Public Notice of Application for Permit

POA-2000-300-M

WORK: Request for a modification to realign 5,500 linear feet of the access road along the shoreline of Cold Bay, for the King Cove Access Project.

Re: Modification to Permit Number 2-2000-0300 (Cold Bay 12)

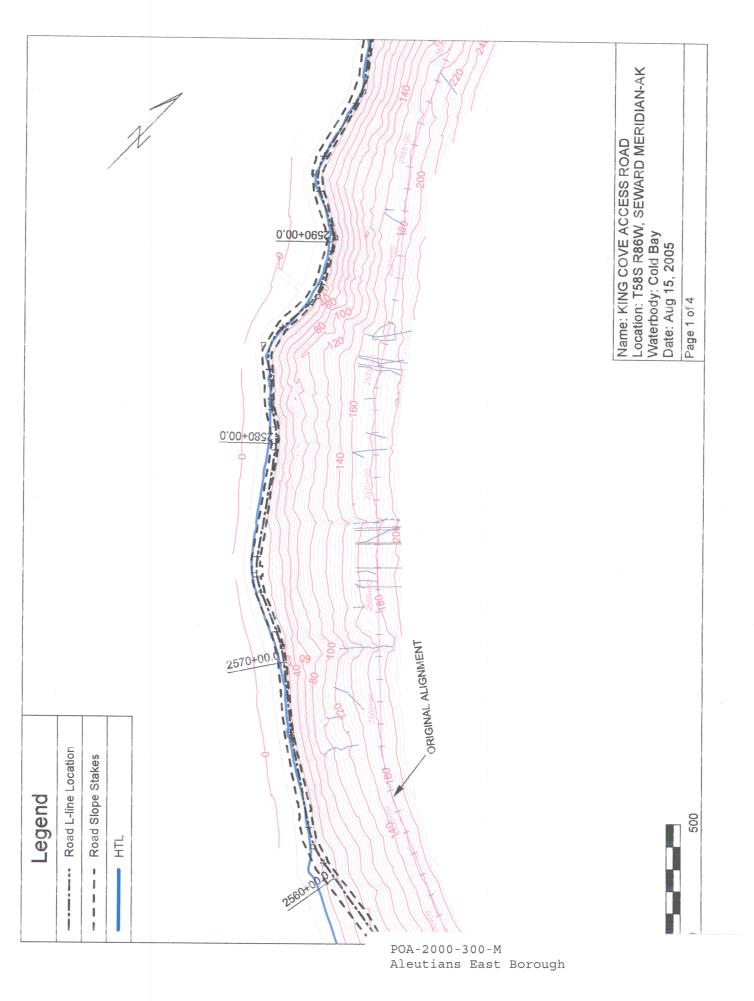
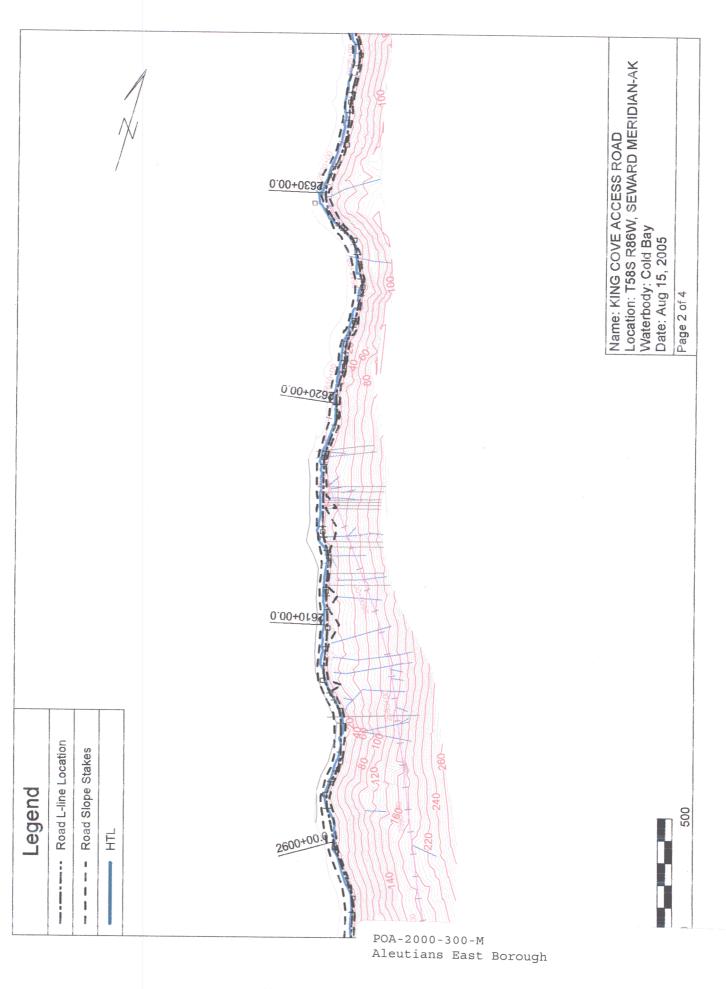
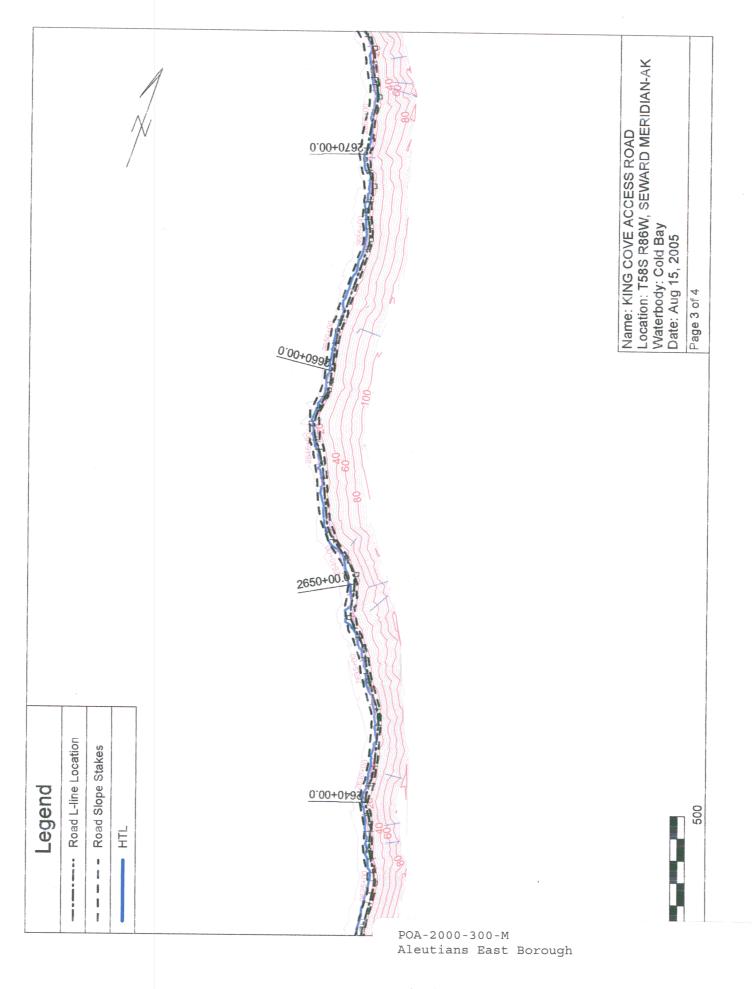
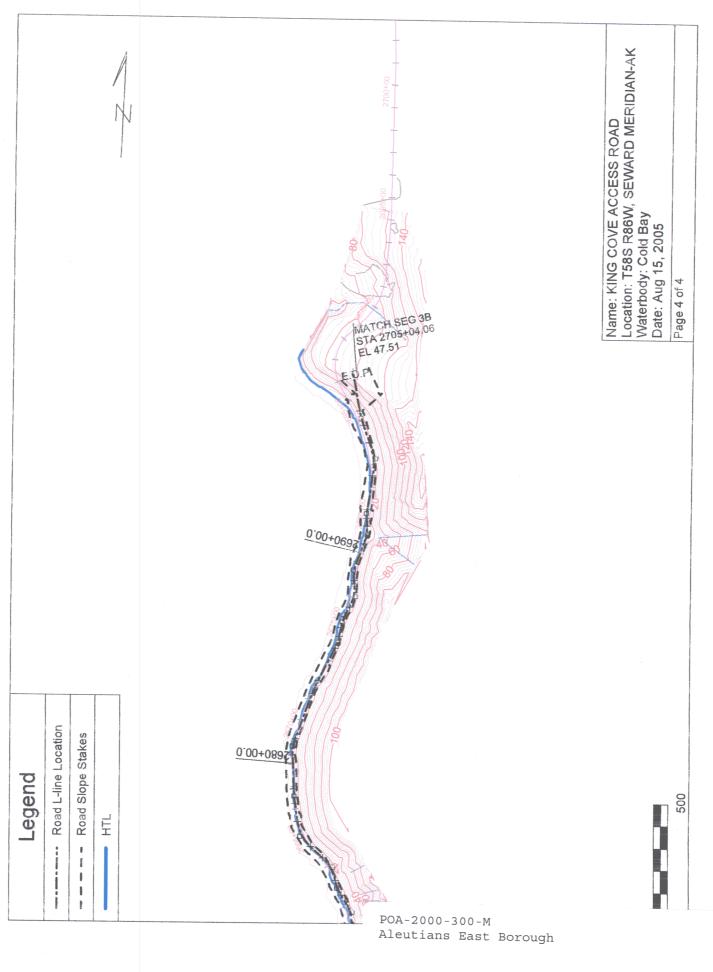
The proposed modification would change the road alignment beginning at about road mile 10.3 (Station 2562+00) to road mile 11.7 (Station 2617+00), where it would rejoin the current, permitted alignment along the shoreline. The details of the road realignment are illustrated in the attached design sheets "Segment 3A – Barney Creek to Tal Point" (note this includes portions of the alignment to the north and south that have not changed). Characteristics of the modified alignment include:

- Avoidance of the steep talus slope at road mile 11.2 and the associated safety, constructability, and cost constraints. The proposed descent to the shoreline at road mile 10.3 follows much gentler slope that does not pose safety or constructability issues.

- 6. Increase in the linear distance of roadway along the shoreline of Cold Bay by approximately 5,500 feet (Station 2562+00 to 2617+00).
- 7. Increase the linear distance of the road fill in marine intertidal beach (below HTL) by approximately 5,500 feet.

- 8. Increase the area of road fill in marine intertidal beach (below HTL) by 2.4 acres to a project total of 6.1 acres.

Increase the volume of road fill in marine intertidal beach (below HTL) by 4,600 cubic yards (based on a typical road cross-section illustrated in Sheet 4 of 12 in Attachment 1).
